DEPARTMENT OF TRANSPORTATION

Contract #: 04-0120F4Cty: SF/ALA Rte: 80 PM: 13.2/13.9File #: 69.28**WELDING INSPECTION REPORT****Resident Engineer:** Pursell, Gary**Address:** 333 Burma Road**City:** Oakland, CA 94607**Report No:** WIR-014377**Date Inspected:** 11-May-2010**Project Name:** SAS Superstructure**OSM Arrival Time:** 700**Prime Contractor:** American Bridge/Fluor Enterprises, a JV**OSM Departure Time:** 1900**Contractor:** Zhenhua Port Machinery Company, Ltd (ZPMC), Changxing Island **Location:** Shanghai, China**CWI Name:****CWI Present:**

Bridge No: 34-0006**Component:** OBG Trial Assembly**Summary of Items Observed:**

Incident Report for Segment 7BW

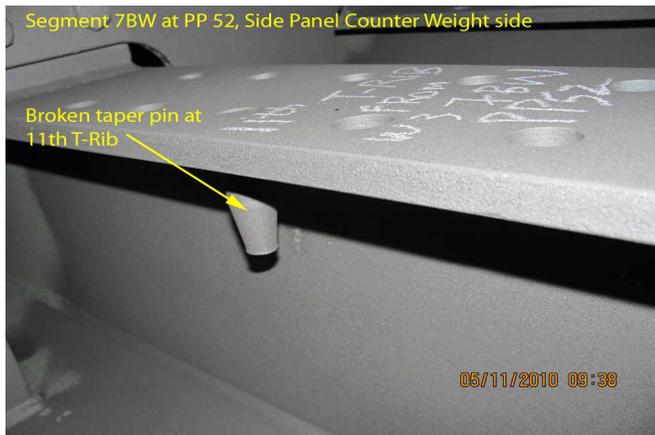
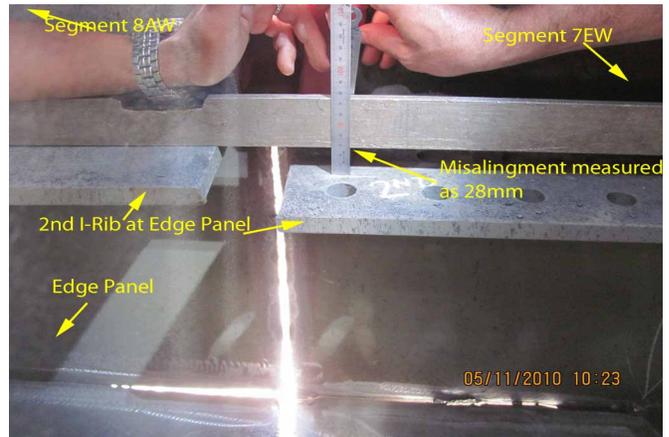
This Quality Assurance (QA) Inspector wrote an Incident Report for flatness of match drilling Template installed between Deck Panel Extension of Segment 7BW to the Cross Beam (CB) #7 between Panel Point (PP) 50, PP 51 and PP 52 for more comprehensive details please refer the Incident Report # 04-0120F4_TL-15_B278_05-11-2010_Gap between the faying surface of Match Drilling plate to CB7 and 7BW Deck Panel between PP50 to PP52 Dated May 10, 2010. Please refer the attached pictures below for more comprehensive details.

Segment 7EW to 8AW Edge Panel

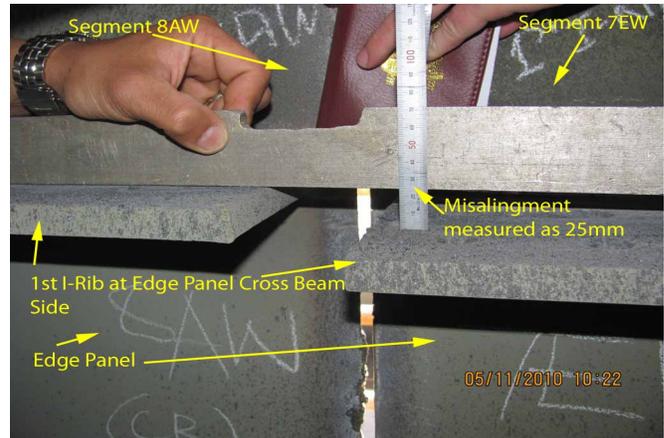
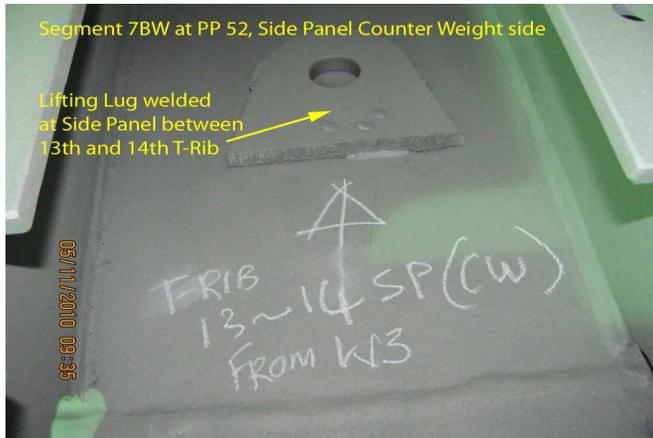
This QA Inspector observed during random visual inspection misaligned Edge Panel Stiffener between Segment 7EW to 8AW (PP 60 and PP61) the deformation for 1st I-Rib measured as 25mm and misalignment at 2nd I-Rib measured as 28mm. The measured and recorded readings were submitted to the Lead and Engineer for review. Please refer the pictures attached below for more comprehensive details.
